Access Compliance Report

Public Rights-of-Way

(Curb Ramps)

Intersection ID: 52551	Main Street: KRISTENS_MARE_DR	Cross Street: ARDREY_WOODS_DR	Location: W
ADA ID: CD11871F1AB0	Ramp Type: PerpDiag	Initial Pass/Fail: Fail	Overall Compliance: No
Severity Score: 1.25			
Codes/Mitigation Info/Possible Solution		Field Measurements/Component Compliance

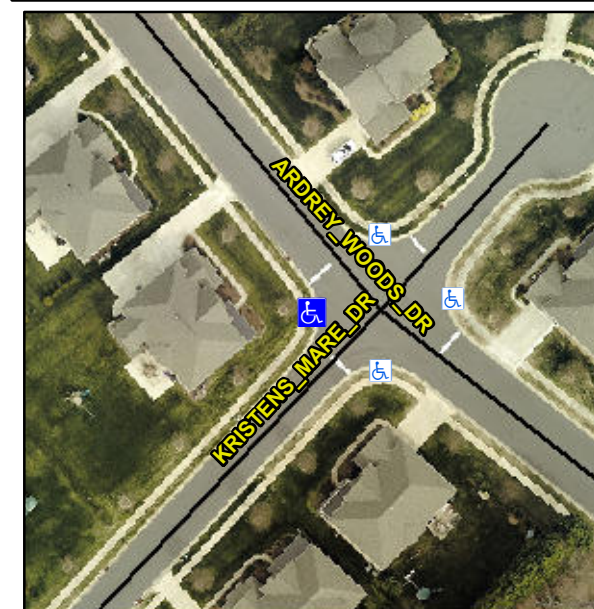
Not Found, R304.5.3

Compliance	Description	Data	Compliance	Description	Data
N/A	Ramp Length (in)	48.0	Yes	Ramp Slope (%)	6.9
Yes	Ramp Width (in)	48.0	No	Ramp XSlope (%)	2.4
N/A	Flare Type LT	N/A	N/A	Flare Type RT	N/A
N/A	Flare Slope LT (%)	N/A	N/A	Flare Slope RT (%)	N/A
N/A	Flare Traversable LT?	N/A	N/A	Flare Traversable RT?	N/A
N/A	Landing Length (in)	N/A	N/A	DWS Provided?	N/A
N/A	Landing Width (in)	N/A	N/A	DWS Contrast?	N/A
N/A	Landing Slope (%)	N/A	N/A	DWS Length (in)	N/A
N/A	Landing X Slope (%)	N/A	N/A	DWS Full Width?	N/A
N/A	Landing Curb? (Y/N)	N/A	N/A	DWS Offset (in)	N/A
N/A	Shared Landing?	N/A			
N/A	Gutter Ponding?	N/A	N/A	Gutter Slope (%)	N/A
N/A	Gutter Lip Ht (in)	N/A	N/A	Gutter X Slope (%)	N/A
N/A	Painted X Walk1?	No	N/A	Painted X Walk2?	No
	X Walk 1 Direction	To SE		X Walk 2 Direction	To NE
N/A	X Walk 1 Width (in)	N/A	N/A	X Walk 2 Width (in)	N/A
	X Walk 1 Slope (%)	1.2		X Walk 2 Slope (%)	1.7
	X Walk 1 X Slope (%)	1.9		X Walk 2 X Slope (%)	2.8

Remove & Replace Curb Ramp With Two New Directional Ramps or Equivalent.
